Technical Bulletin #774

Transmission: 4T40E, 4T45E

Subject: Neutral flare and/or RPM flare while in drive, no 1-2 upshift, service engine soon light illuminated, DTC P1810, DTC P1815 set

Issue Date: June, 2003

Figure 1

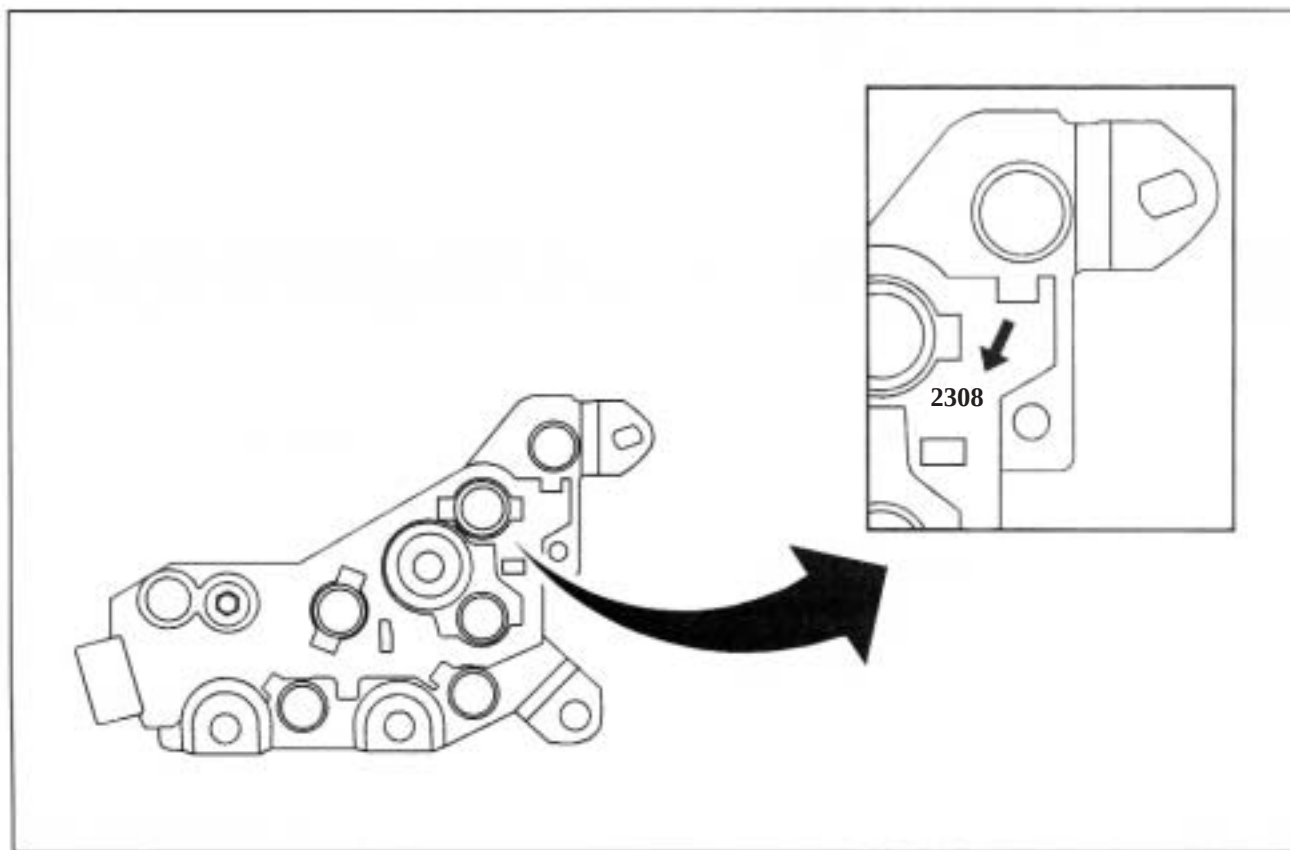
Important: Before installing the new TFP switch, inspect the date code stamped in the switch. The date code MUST BE 2308 or higher. Refer to Figure 1 on the next page.
